Prowell Woodworks
800.466.1850

GATE #1 ENTRY COURTYARD-- -PRODUCT SPECIFICATIONS / NOTES

PO#25-- -GLASSMAN Dbl Gates Style #72 (2-1/4" thickness)

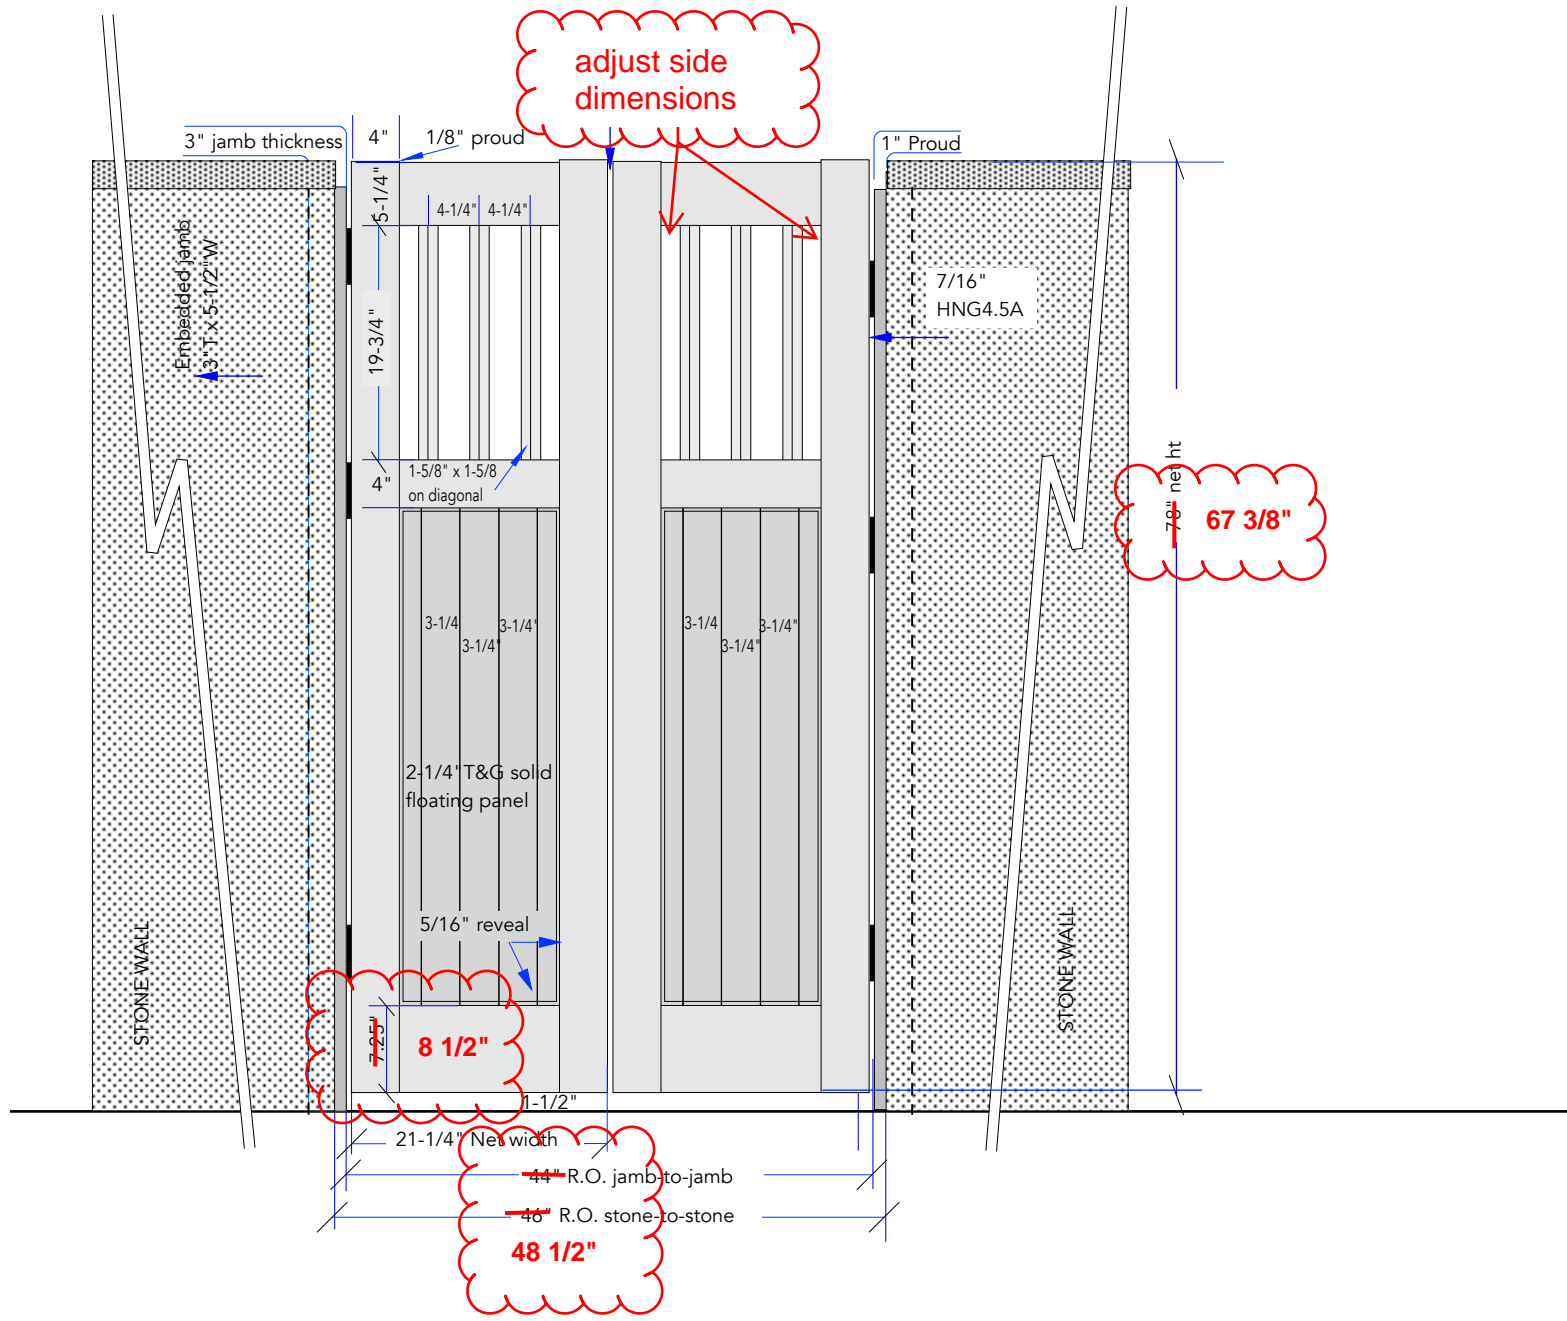
- Top Dimensions:**
 - 3" jamb thickness
 - 5-1/4" (multiple locations)
 - 1/8" proud
 - 5/8"
 - 1" Proud
- Left Side (Stone Wall):**
 - 7/16" HNG4.5A
 - EQ
 - Embedded jamb 3" T x 5-1/2" W
 - EQ
 - 10"
 - 8-1/2"
- Window Unit:**
 - 5-1/2" (multiple locations for slats)
 - 5-1/2" W T&G solid floating panel-2-1/4" T
 - 5/16" reveal
- Right Side (Stone Wall):**
 - EQ
 - 88-1/8" net ft
 - 73 1/4"
- Bottom Dimensions:**
 - 1-3/4"
 - 37-5/8" Net width
 - 76 3/4" R.O. jamb-to-jamb
 - 78 3/4" R.O. stone-to-stone
 - 69"
- Annotations:**
 - adjust widths to maintain 5 slats (circled in red)
 - STONE WALL (on both sides)

no t-astrical - why? RH Active per plan.

Viewed on approach from street
DBL GATES #6-- AT POOL

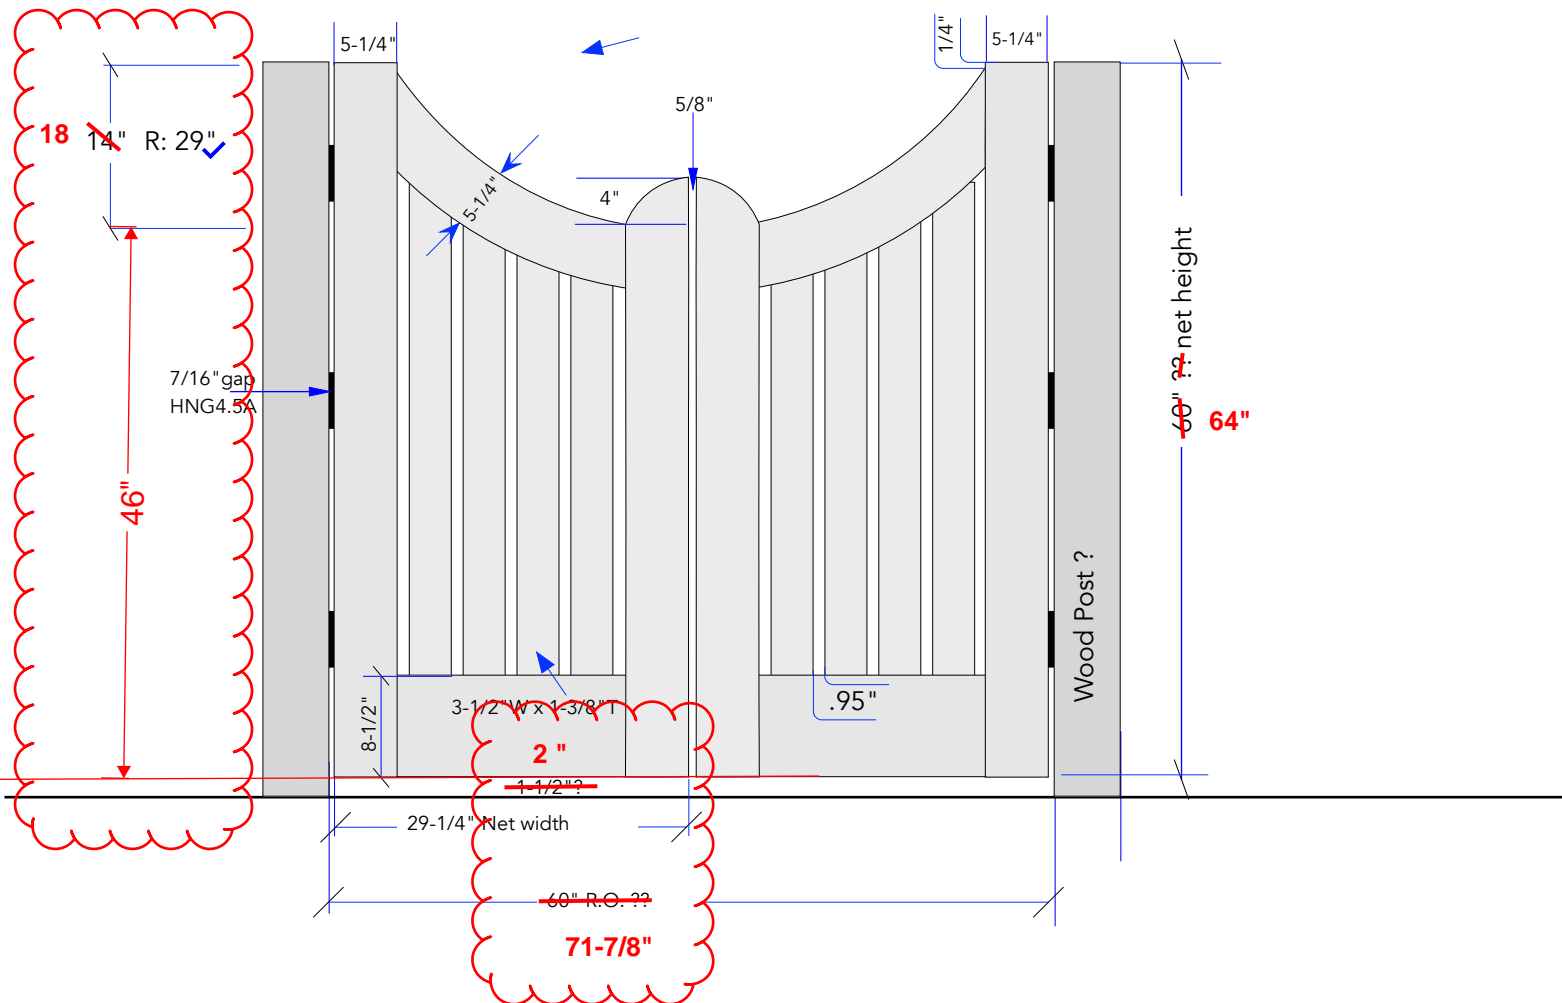
no t- astrical ?
Plan shows RH active, inswing.
